**Parks and Recreation Board Agenda
Department of Public Services
851 South Eton-Conference Room
Tuesday, June 4, 2024
6:30 PM**

As the Board prepares for the second review of the preliminary plan for Booth Park Entry Plaza & Trail Improvements as designed by Grissim Metz Andriese Associates at the June 4, 2024 Parks and Recreation Board meeting, included in the packet are the following:

SUBJECT: Booth Park Entry Plaza and Trail Improvements – Preliminary Park Design and Concepts Plan

Preliminary Design
Site Constraints
05.07.2024

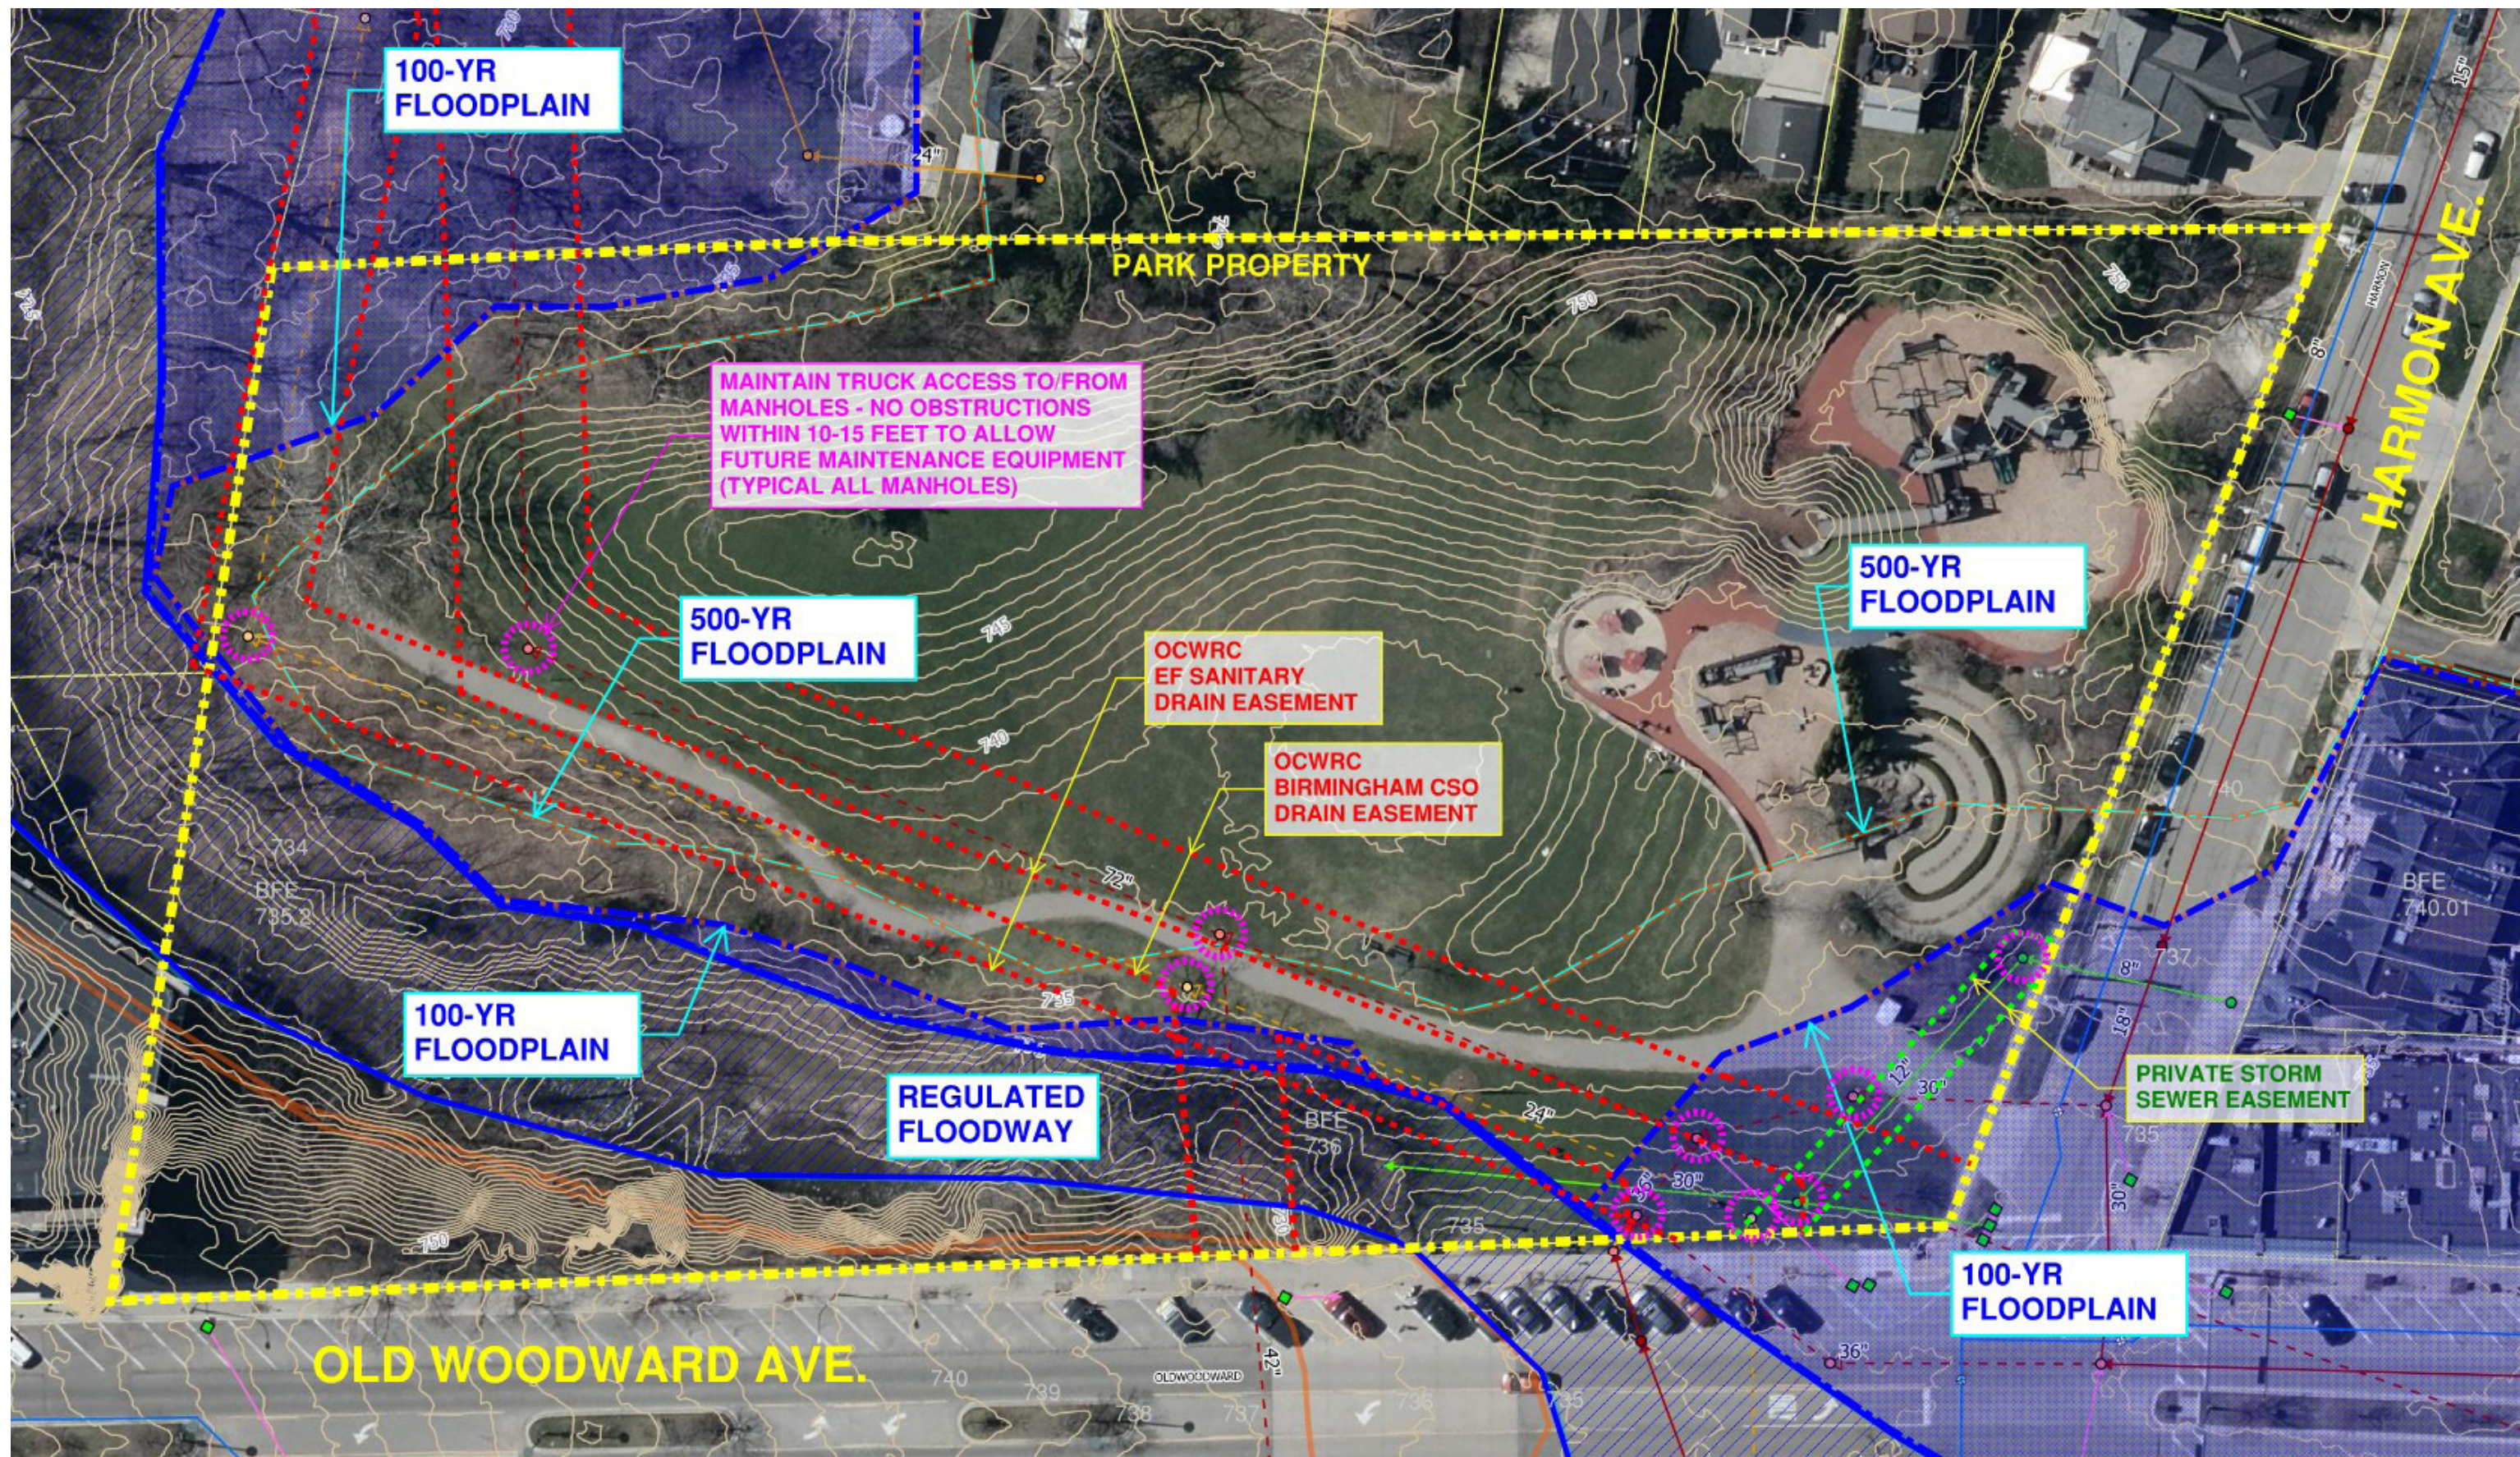
I am pleased to have the opportunity to provide some feedback regarding the preliminary designs for the Booth Park Entry Plaza and Trail Improvement project dated May 7, 2024. As a general observation, the concept plans appear to be very well done. They are attractive, easy to understand, and provide me with a lot of confidence that the consultant team is really paying attention to all of the competing interests and agendas that all involve this property.

In February, I provided a detailed memorandum (attached) regarding the specific objectives of the Birmingham Plan 2040 as they relate to this project, which involved the park space as well as the Rouge River corridor. Fortunately, I believe that the concept plans address most, if not all of the recommendations related to the park space that I quoted from the 2040 Plan. The plans contain much more seating, café/vendor accommodations, restrooms, and the paved plaza that has been a goal of ours since the Downtown Birmingham 2016 Plan. At this time, I would only feel the need to encourage further the use of pervious paving materials, whether it is pavers or otherwise. In my opinion, this should absolutely be done in areas "1" and "4" which contain seating, but would be encouraged along what is now labeled as the 10' wide concrete path. Perhaps small accent portions could be introduced with pervious pavers.

In regards to the 2040 Plan's recommendations on the Rouge River corridor, which were numerous, much of this plan would aid in furthering objectives such as improving the ecosystem and providing better amenities. A lot of the recommendations related to the Rouge are admittedly a bit larger than this project alone, but every little bit helps.

- Every new or improved landscape bed as a part of this project, as well as future projects along this trail, should without exception be native plantings, and all new trees should be native species. In my opinion, this should be clearly stated in the "Note Key" in items such as 8, 15, 16, 23 and 24. This may already be the approach, but I believe that being explicit with our intentions will go a much longer way.

- The trail gateway signage and the acknowledgement to the recently approved Wayfinding and Signage Master Plan is well received. Any new sign design will need to go before the Wayfinding and Branding Committee, but my initial reaction is very positive.

- There is currently a piece of public art located near the entrance that is not noted on this plan. I have been advised that the City has asked the artist to remove the piece, but it could be noted on this plan that the art is going away as to not confuse anyone. In addition, the Planning Department would be supportive of alternate displays of public art, the possible placement of such could be added to this plan to give direction to staff when considering future donations or loans.

RESTROOM BUILDING
PRE-FABRICATED

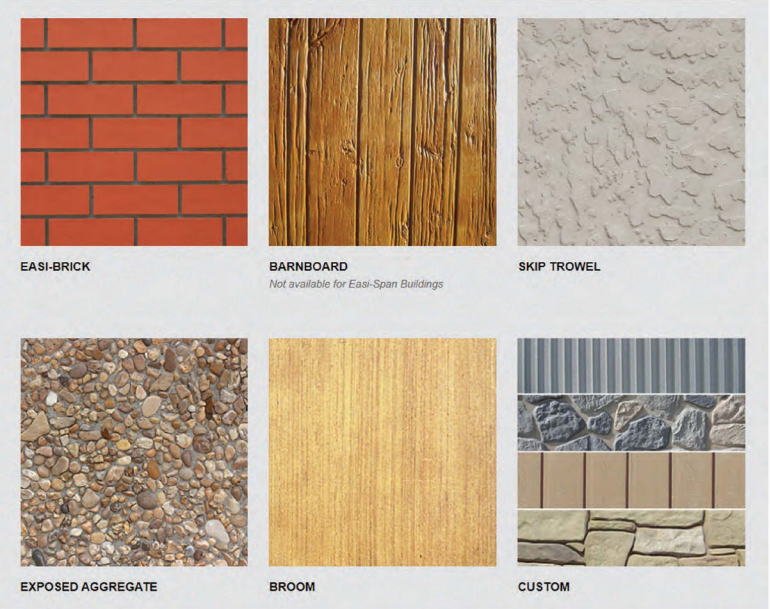
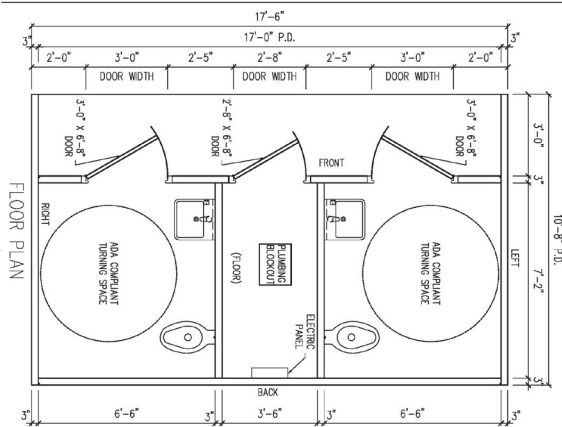
Kaplan is concerned about the location the restroom which is front and center of the park and it will be a feature from not only the street, but also as an entrance to the park and there is a lot of underground and having it hidden with planters will reduce the path from 10ft. to 4ft.

I have some concerns over our ability to see into the park. This is an area that is a teen hangout on the evenings, particular on the weekends. Due to the play structure, it can already be difficult but with the additional trees and restrooms and other features it will be impossible to check the park without walking through it. Currently we only have one camera at this location but I would request possibly as many as two additional cameras to provide the ability to check the park. These locations would need power supply. We can look at potential locations, but maybe your designers can add some insight in terms of future site lines once constructed and the ability to construct with a power supply in place.

- 1. Exposed aggregate concrete runway with fashion quotes inlays
- 2. Owner donor plaque
- 3. Butterfly benches
- 4. Butterfly plant material surround
- 5. Retaining wall may be required

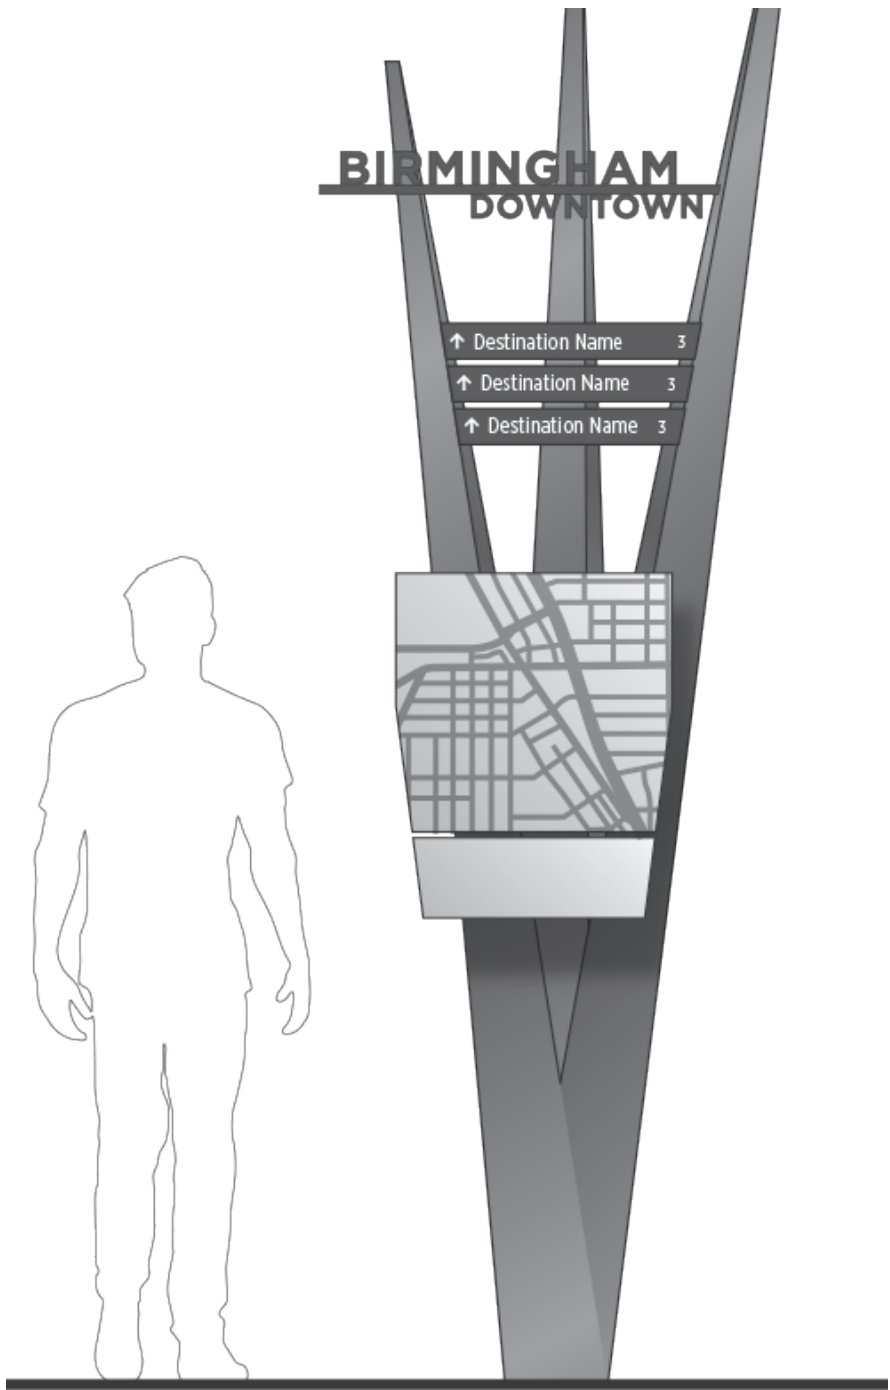
Peterhans showed the concept plan of the area for the possible donor. The concept includes butterfly benches and plantings with a walkway leading to the butterfly benches.
